FINAL DRAINAGE REPORT FOR CLAREMONT BUSINESS PARK 2 FILING NO.1

EL PASO COUNTY, COLORADO

AUGUST 2020

Project #44-037
PCD – SF- 20-014

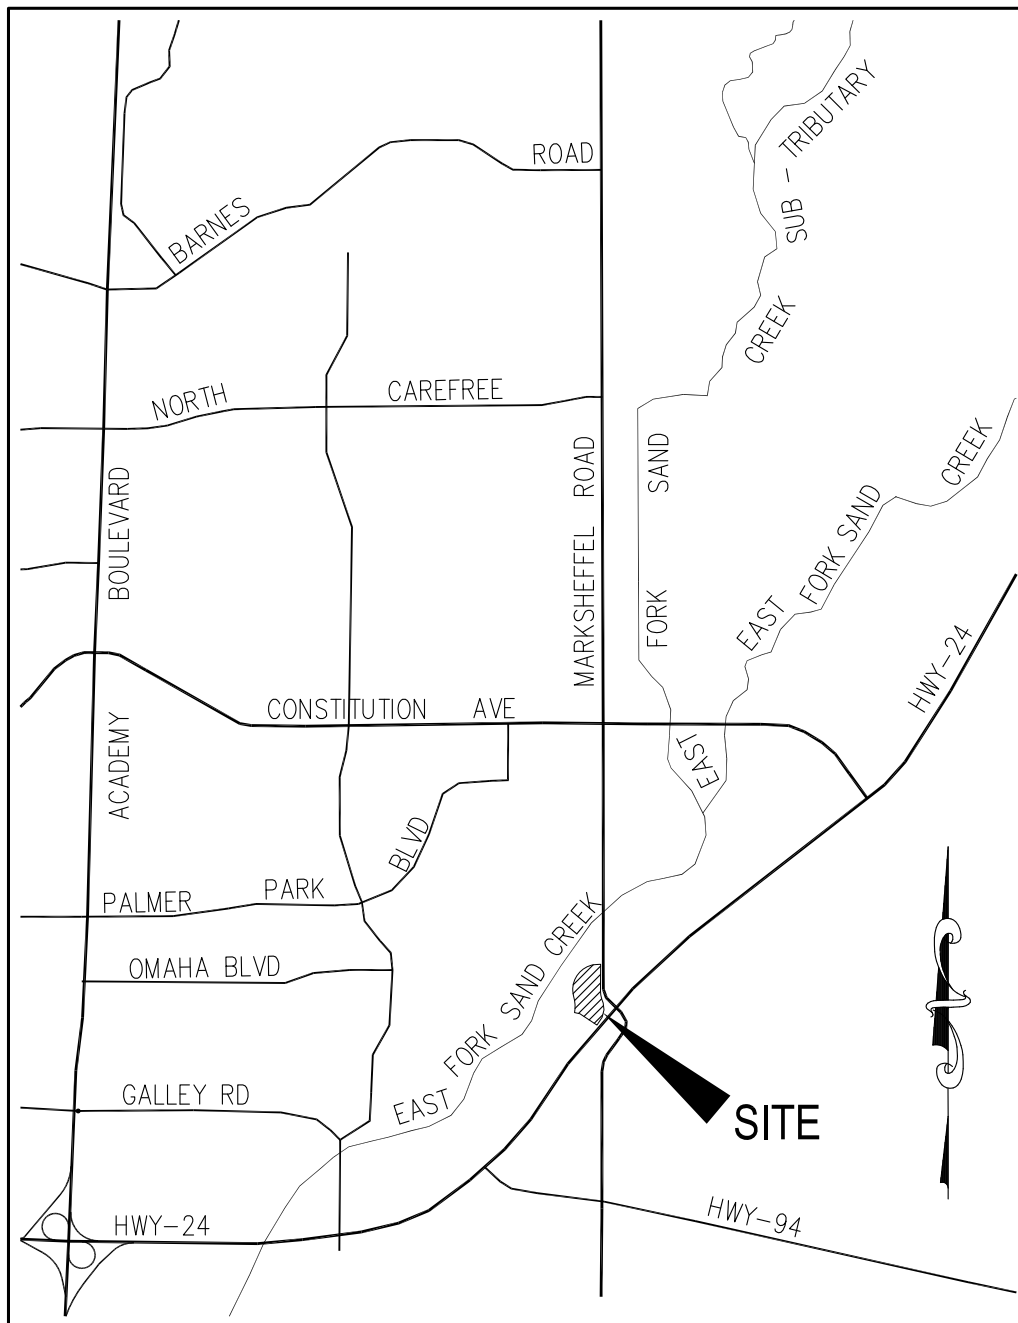
It appears that this may be the calculated impervious of basins B1 & B2. Please **also** state that the previously paid fees were based on 80% impervious as shown in the excerpt attached to your report and to match what is indicated in the letter of intent.

**COMMENT ADDRESSED.
CHANGED TO 80% AND TEXT
ADDED TO MATCHES
LETTER OF INTENT.**

INLET ON A CONTINUOUS GRADE

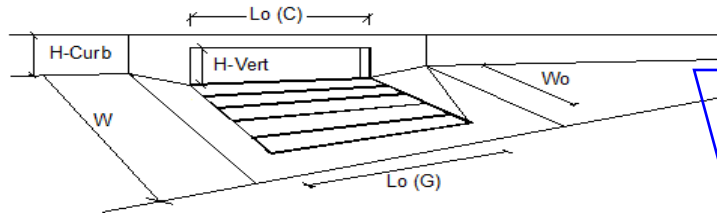
Review #1: Revise so that it matches the CD's and drainage plan. Inlet 1 is indicated as 15' on the CD's.
Review 2: unresolved.

COMMENT ADDRESSED. LENGTH OF SINGLE UNIT IS 5' , TOTAL NUMBER OF UNITS IS 3, EQUAL TO A 15' INLET. PER CDOT STANDARD PLAN DETAIL M-604-12

INLET ON A CONTINUOUS GRADE

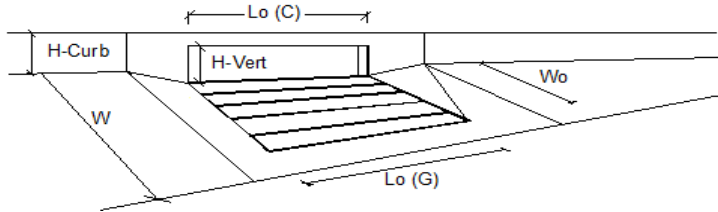
Review 1 comment: Revise so that it matches the CD's and drainage plan. Inlet 2 is indicated as 10' on the CD's.
Review 2: Unresolved. Revise to match the CD's and drainage plan which now indicate a 15' inlet.

COMMENT ADDRESSED. LENGTH OF SINGLE UNIT IS 5' , TOTAL NUMBER OF UNITS IS 3, EQUAL TO A 15' INLET. PER CDOT STANDARD PLAN DETAIL M-604-12 INLET 2 IS A 15' INLET

INLET ON A CONTINUOUS GRADE

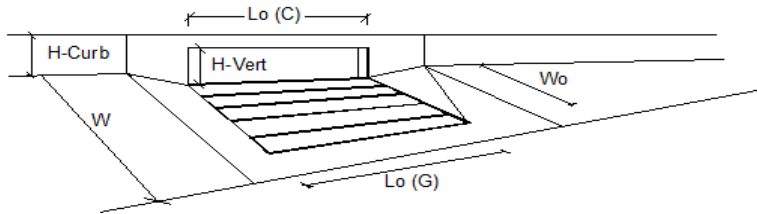
Review 1: Revise so that it matches the CD's and drainage plan. Inlet 4 is indicated as 10' on the CD's.
 Review 2: Unresolved. Please revise to match the CD's and drainage plan which now indicate a 15' inlet.

**COMMENT ADDRESSED. LENGTH OF SINGLE UNIT IS 5' ,
 TOTAL NUMBER OF UNITS IS 3, EQUAL TO A 15' INLET. PER
 CDOT STANDARD PLAN DETAIL M-604-12 INLET 4 IS A 15' INLET**

STRM 7 PROFILE - 100 yr

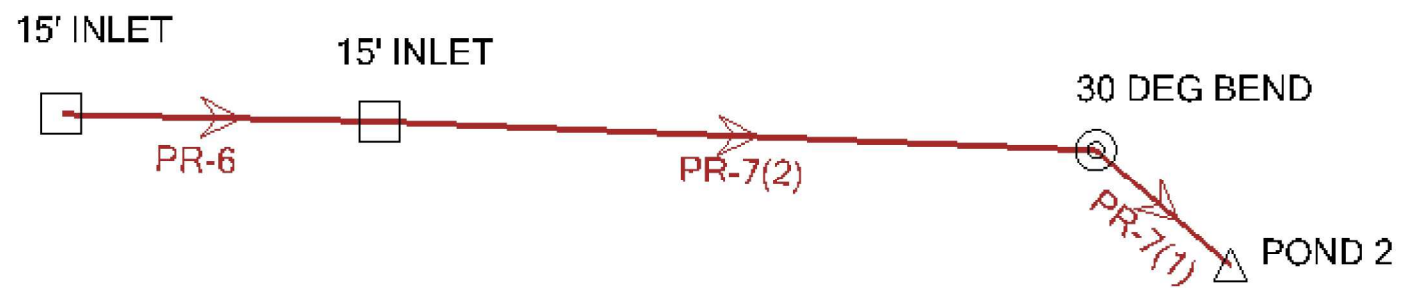
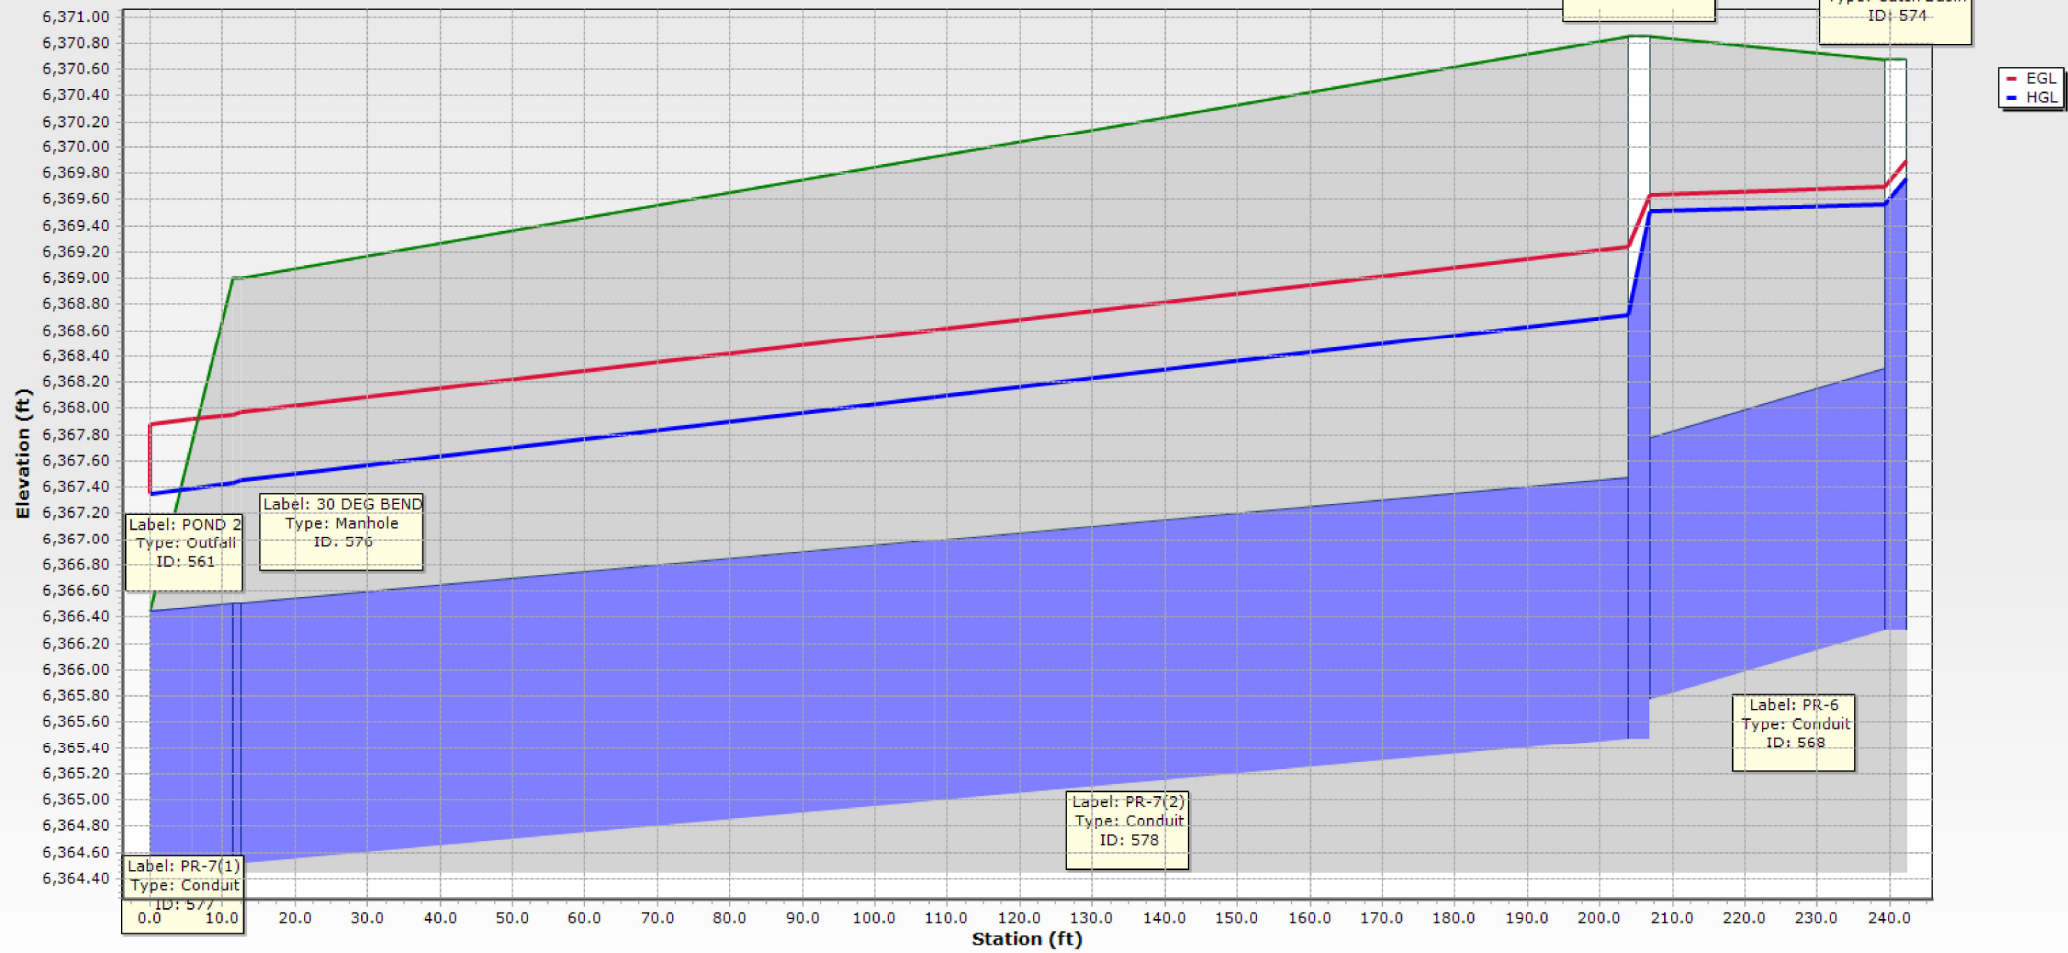
Review 1: The flow is greater than the capacity. Revise accordingly.
Review 2: Unresolved

COMMENT ADDRESSED. DUE TO THE 100-YR WATER SURFACE ELEVATION IN POND 2 AND THE CLOSE PROXIMITY OF THE STORM INLET 2 STORM 7 SHALL BE PRESSURIZED. STORM 7 IS ALSO A PRIVATE SYSTEM.

NOTE ADDED STORM 7 BETWEEN STATIONS 1+06.13 AND 3+06.97 SHALL HAVE GASKETED, WATERTIGHT JOINTS AND ADHERE TO PERFORMANCE STANDARDS PER ASTM D3212 FOR HP PIPE.
